WOODMEN HILLS METROPOLITAN DISTRICT
 THERIOT CONCRETE WATER TANK
 GRADING & EROSION CONTROL PLAN

PCD PPR251

C5
 SHEET 5 OF 2

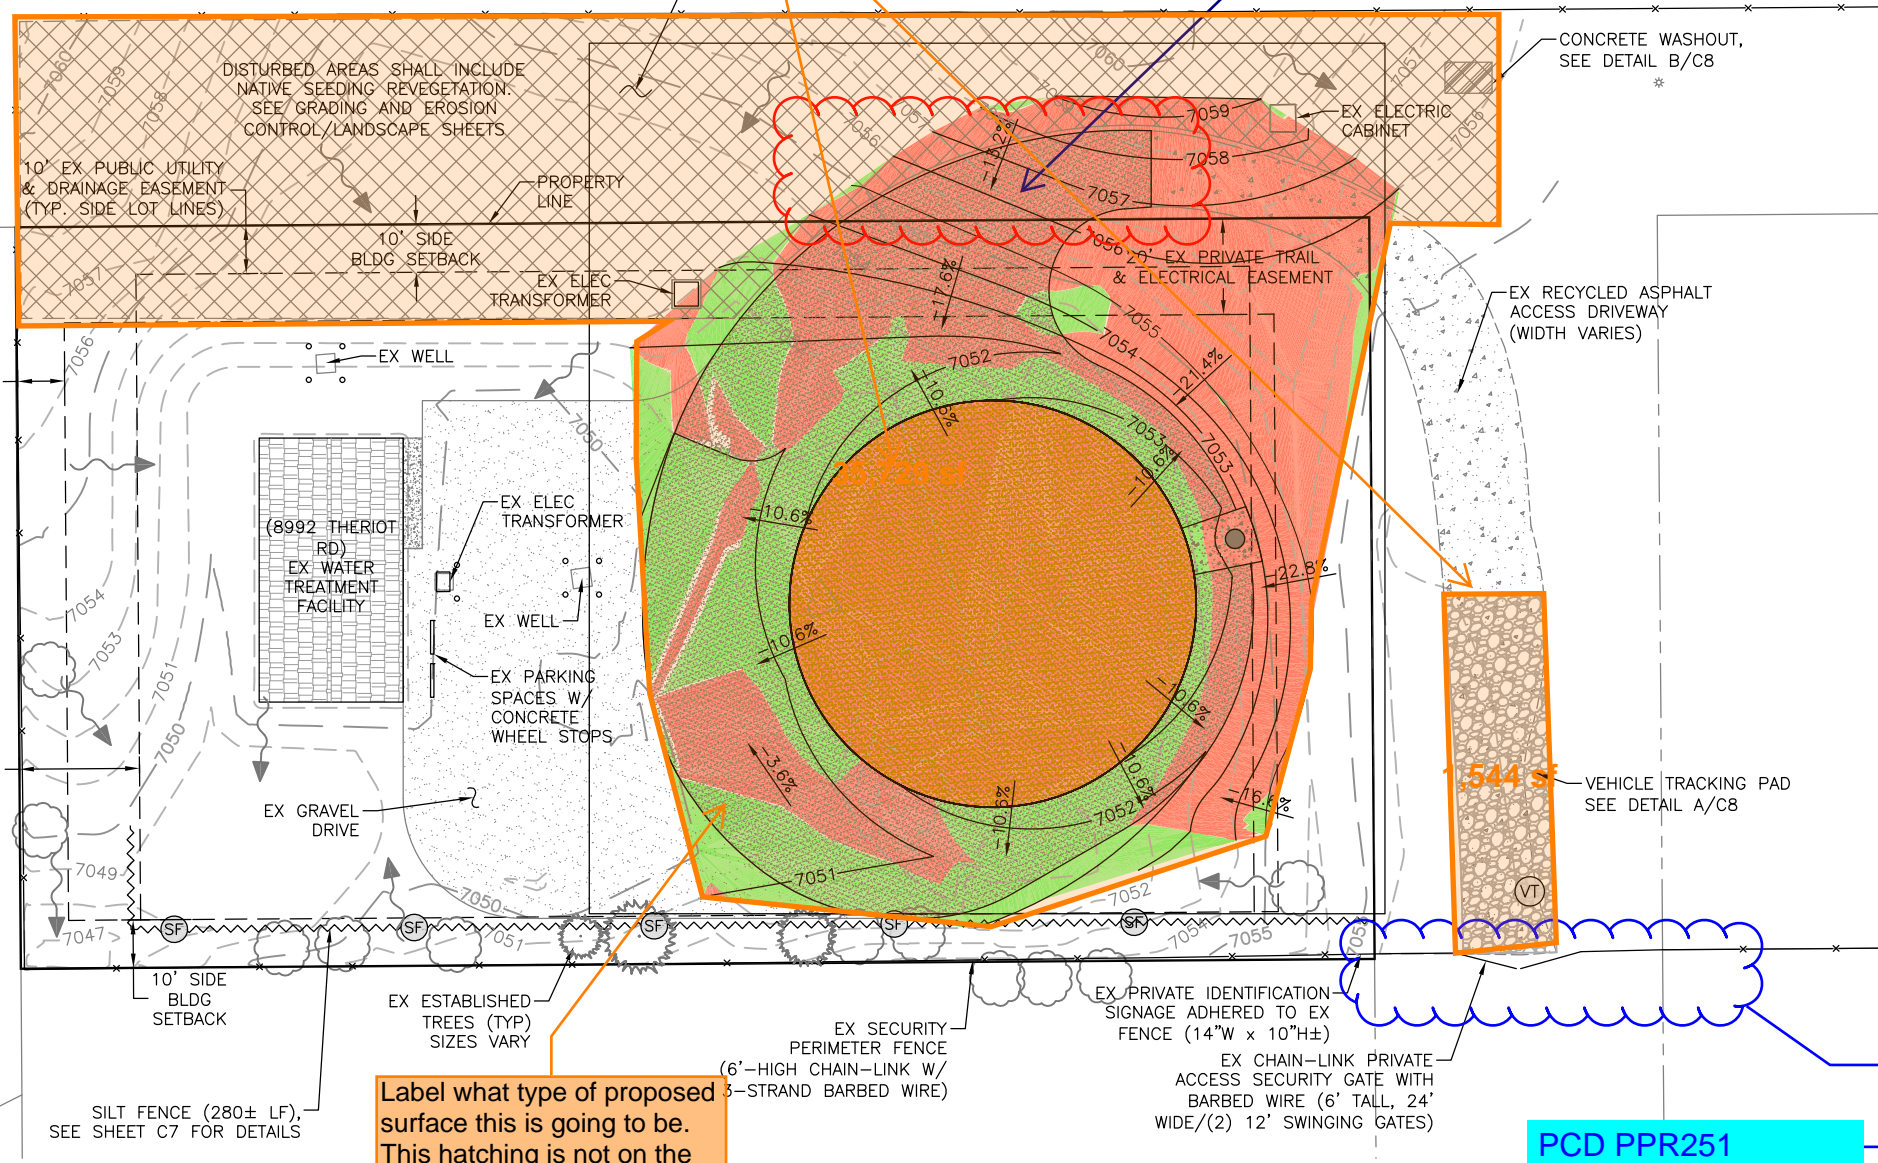
While the proposed disturbances on this plan appear to be <1ac, recent aeriels show that the majority of this 1ac lot, plus the 1/3ac being utilized north of the lot, and the access area east of the lot, are mostly disturbed. Meaning the current total site disturbance is >1ac. This means that a ESQCP and maybe even a PCM is required. Please discuss all disturbances in a Drainage Letter to clarify the need for an ESQCP and/or PCM.

If <1ac, then we can simplify this whole process and remove the req for all of the ESQCP-related docs. So I am going to hold off on commenting with further detail on the other ESQCP docs until we have this clarification to save time for everyone.

This needs to be regraded and changed to not encroach into adjoining property off the lot. Address this in the drainage letter and redesign. Correct on site dev plan

Please provide sheet index

Please provide standard EPC GEC plan signature statements and blocks

Label what type of proposed surface this is going to be. This hatching is not on the Legend above.

Remove gate out of ROW

correct sheet numbers on all sheets

C6
SHEET 6 OF 2

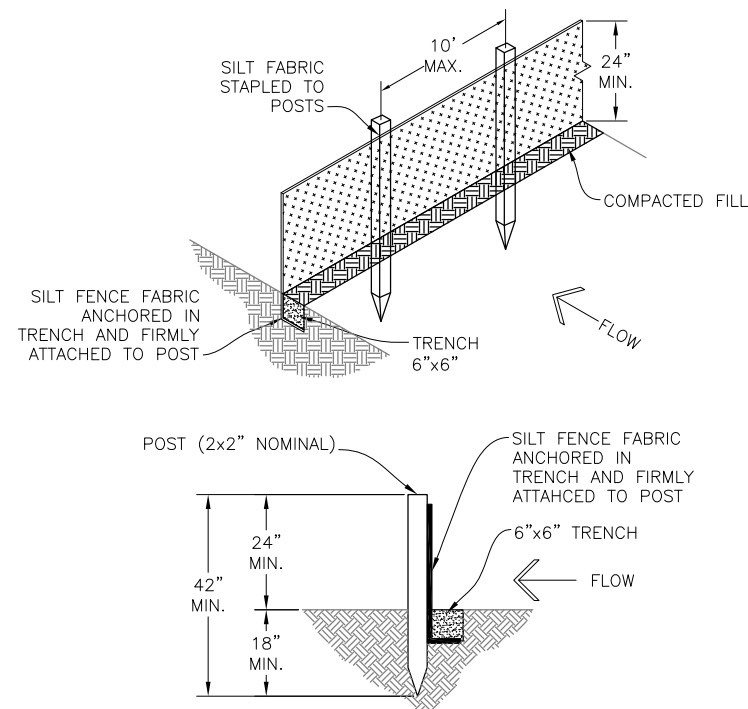
update

Add design detail for pervious pavement
